WASTE & SERVICING STRATEGY ADDENDUM

Salboy Central Ltd

Viadux Phase 2 Minor Material Amendment

April 2022

Figure 3.1 Bin Store Location on Trafford Street

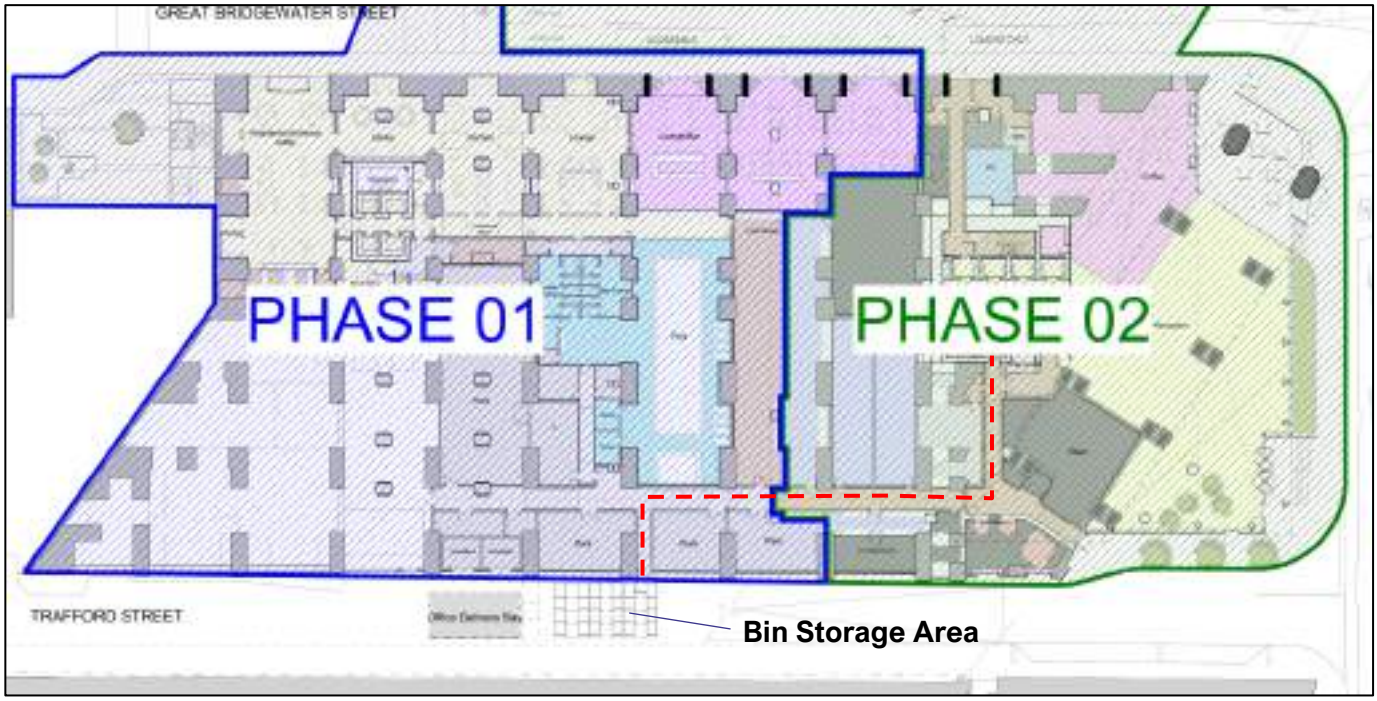
3.10 The bin storage area is shown in **Figure 3.1** below using the existing secure storage area. Within the storage area there is space for other occasional waste (such as furniture) to be stored.

Phase 2 Ground Floor (Approved 2020)

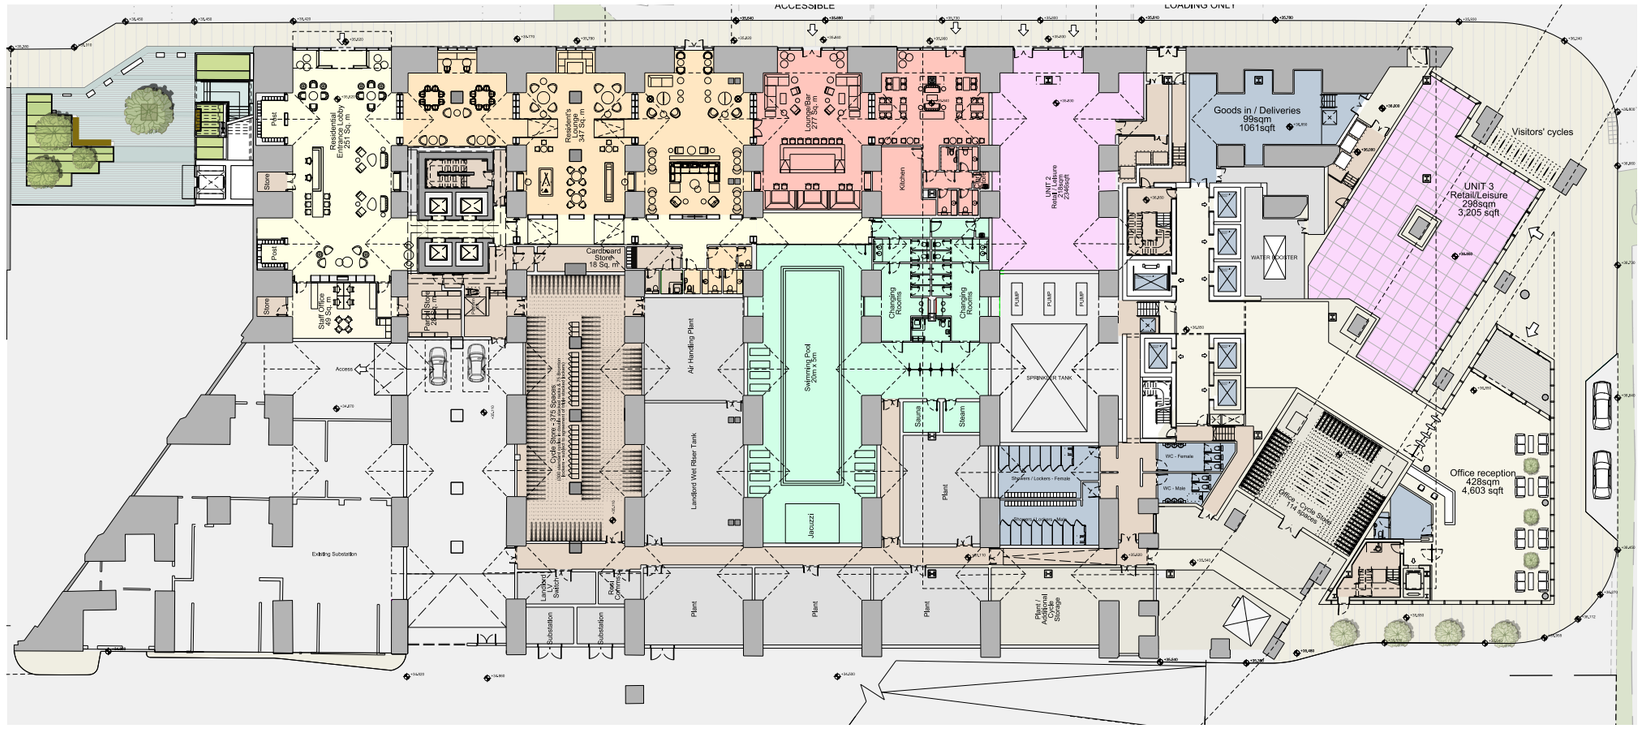
A - The office core has been rotated through 90 degrees and an additional passenger lift added to improve the performance / waiting times.

B - The goods lift has been updated to include a double sided opening car at ground floor with direct access to back of house for servicing. The rotation of the core reduces the impact and demolition of the listed viaduct.

C - The main servicing of the office has been moved from Level 01 (Man Central service yard) to Trafford Street.

D - The refuse storage at Level 01 has been relocated underneath the existing servicing ramp to Man Central service yard.

E - The lay by to Albion Street has been omitted and the full pavement width restored improving the pedestrian environment.
(Lounge bar / coffee shop servicing remains from the loading area on Great Bridgewater Street.)

F - The substations have also been relocated from Level 01 Man Central service yard to ground floor with direct access from the service road to Albion Street.

2017 APPROVED DESIGN

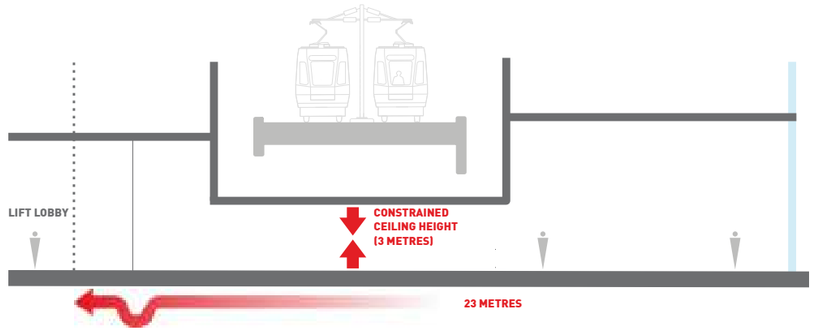
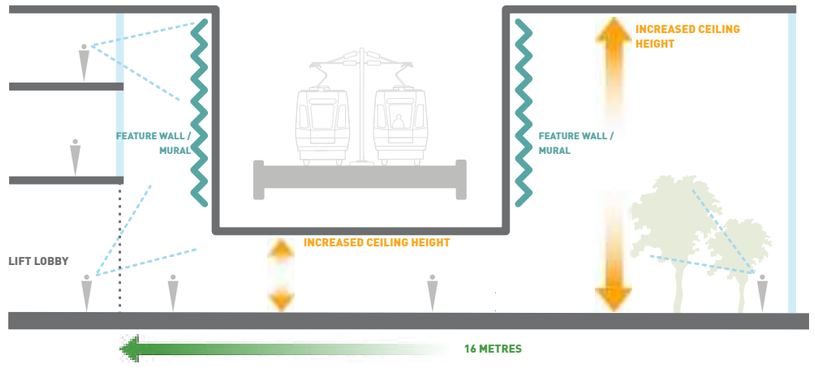
B - The office entrance has been moved further down Albion Street to remove internal level changes and increase the headroom available underneath the tram bridge.

- Lack of sense of arrival
- Constrained headroom under metrolink

- Creates a sense of arrival
- Incorporates tram encapsulation as artwork / mural
- Releases the space for amenity

CONSENTED

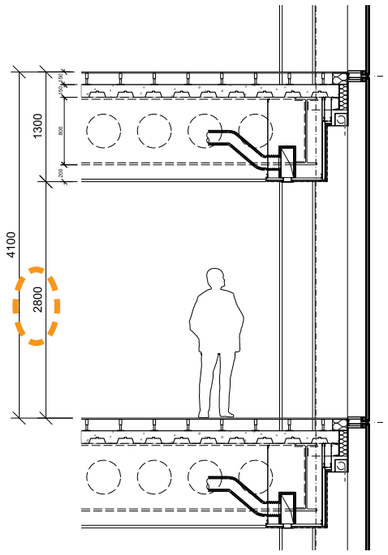
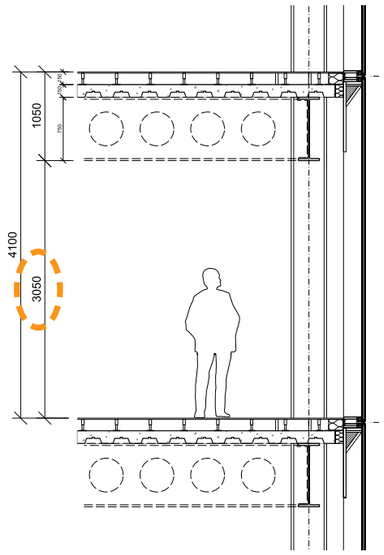
A - The office floor to floor height has been revised following a review of the main structural beam depth and the client decision to have exposed soffits and services with no ceilings.

As a result the floor to floor height has been revised from 4100mm to 3950mm with a 2900mm floor to underside of structure. (BCO Guide to Specification - Best practice for offices – 2019 recommends a clear height of 2.8 to 3.2m for spaces over 18m in depth).

This provides a saving of 150mm per floor which equates to 1800mm over the 12 office floors.

B - The overall reduction in height of 1450mm (1800mm - 350mm) resulted in the decision to add a further office floor (3950mm) which results in an overall increase in height of 2500mm.

FACADE FRIT STRATEGY

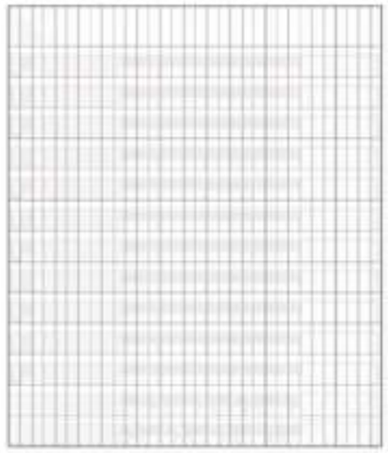
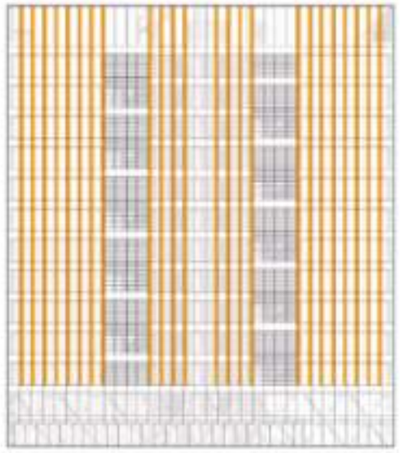
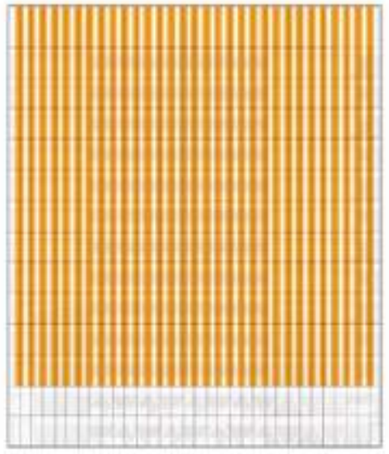
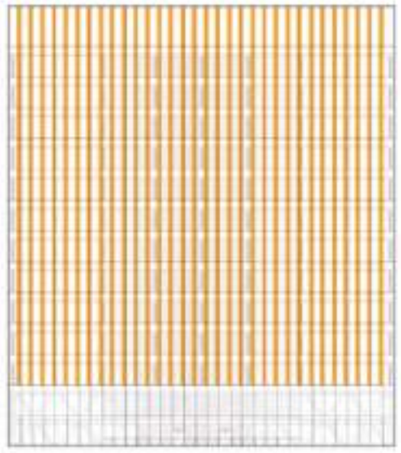
C - This has informed the percentage of ceramic fritting applied to the glass to control the level of shading and subsequent reduction in heat gain. Rather than remaining constant, the level of opacity has been amended to respond to orientation; the south elevation employs 66% fritted panels, the east & west 33% and the north remains clear. This reduces overheating, cooling costs and saves heating energy.

0% Frit

33% Frit to clear glazed units

66% Frit

33% Frit to clear glazed units

Proposed Scheme

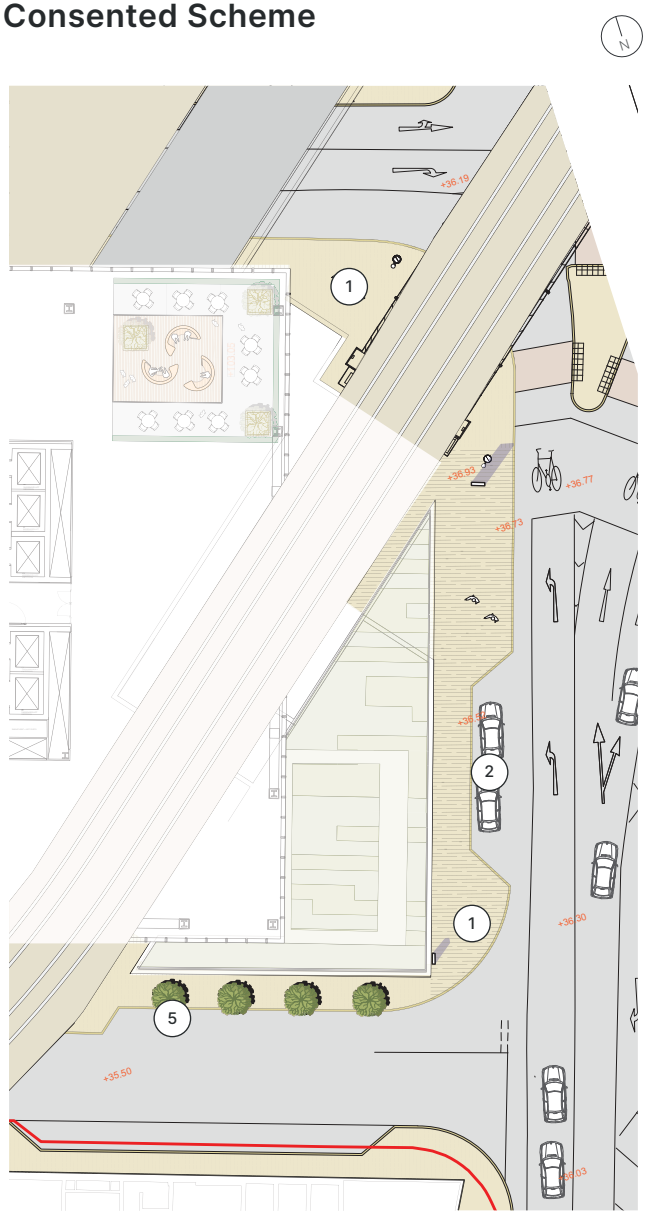
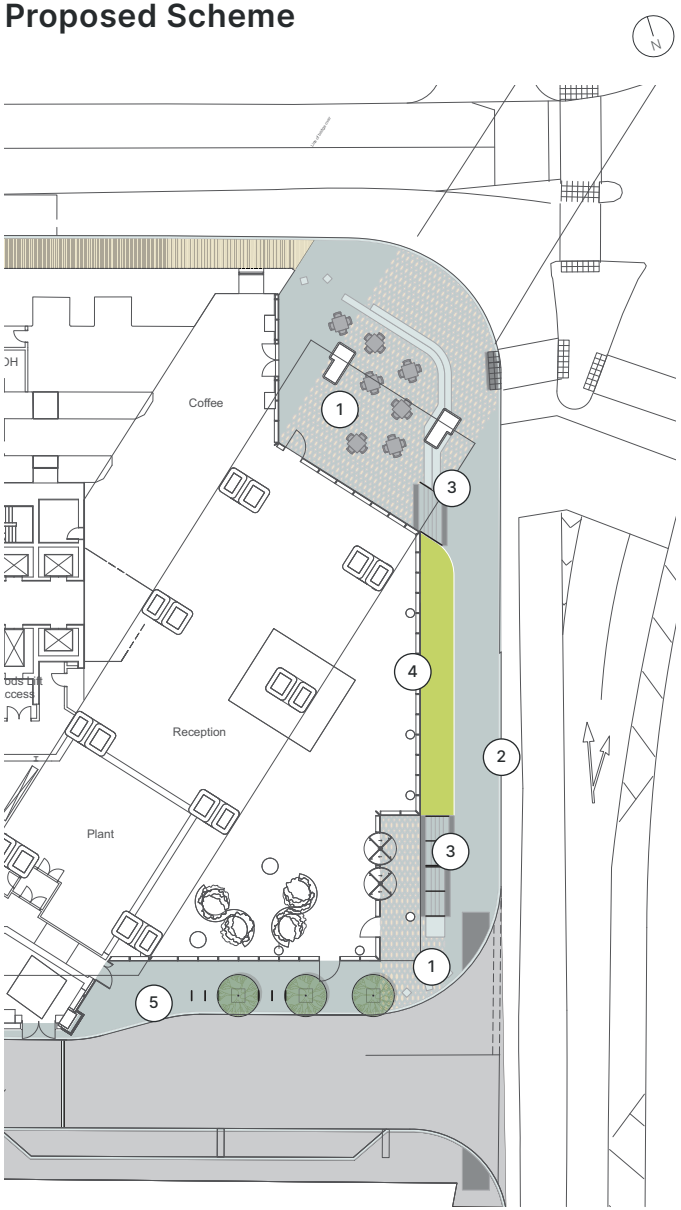
1. Paving materiality has been revised from yorkstone to granite with bespoke units.

2. Omission of loading bay to Albion Street.

3. Introduction of steps and seating walls.

4. Introduction of soft landscaping along eastern building elevation.

5. Omission of one tree to the south of the building.

Reason: To create a stronger sense of arrival, and acknowledgement of the heritage of the existing architectural features and heritage.

Reason: Servicing to be carried out from Trafford Street.

Reason: To accommodate level change around the site.

Reason: To enhance amenity and biodiversity value in the public realm and to provide a visual connection with the green elements on the building above.

Reason: Due to the tree pit clashing with existing services in the footway.
